# Access Compliance Report

## Public Rights-of-Way

### (Curb Ramps)

Intersection ID: 11748	Main Street: BERRYHILL_RD	Cross Street: FLEETWOOD_DR	Location: E
ADA ID: E9B2800B9939	Ramp Type: BlendTrans1	Initial Pass/Fail: Fail	Overall Compliance: No
Severity Score: 33.75			
Codes/Mitigation Info/Possible Solution		Field Measurements/Component Compliance

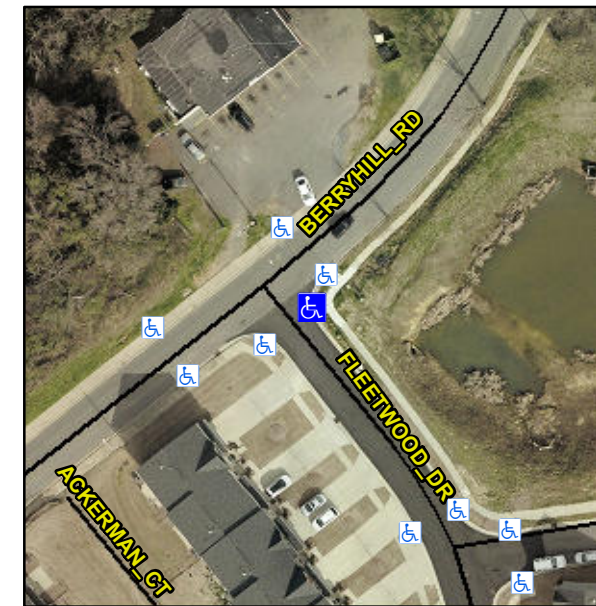
**Remove & Replace Curb Ramp With Two New Directional Ramps or Equivalent.**

**Not Found, R304.5.1, R304.5.3**
